REGULATION No. 16  
(Safety-belts)

Proposal for draft Corrigendum 1 to Supplement 19 to the 04 series of amendments  
to Regulation No. 16

Proposal submitted by Japan <sup>\*/</sup>

Annex 8, the figure, correct to read:

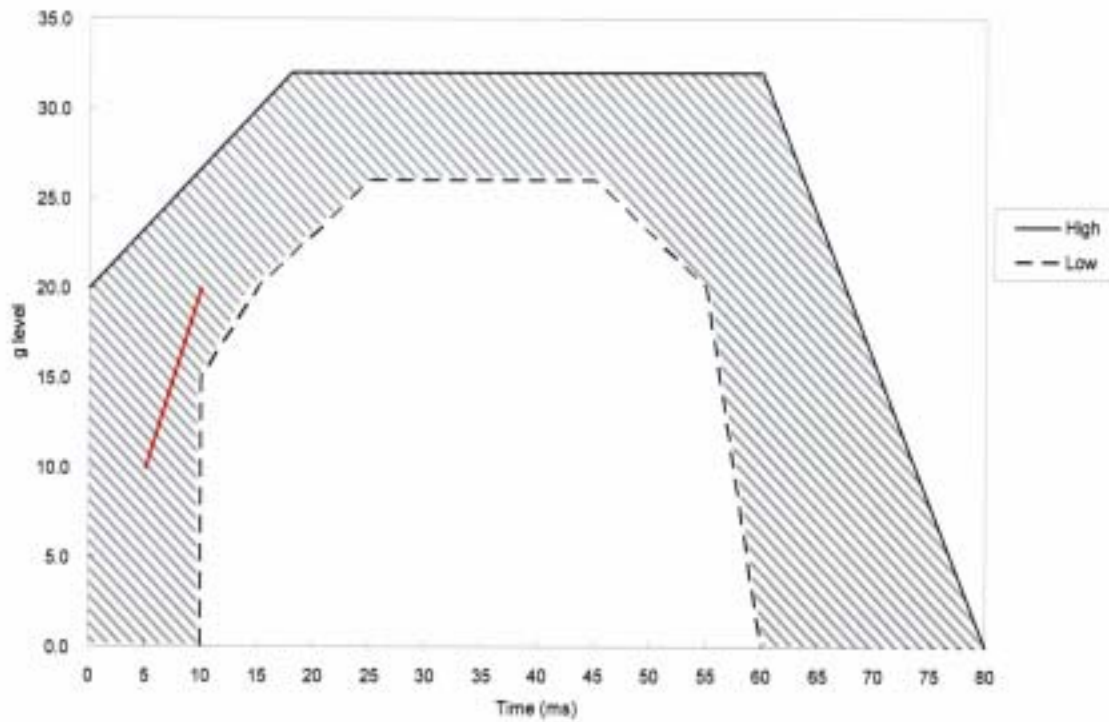
The hatched area is not shown in the Figure in Annex 8. Therefore it needs to be added to the Figure.
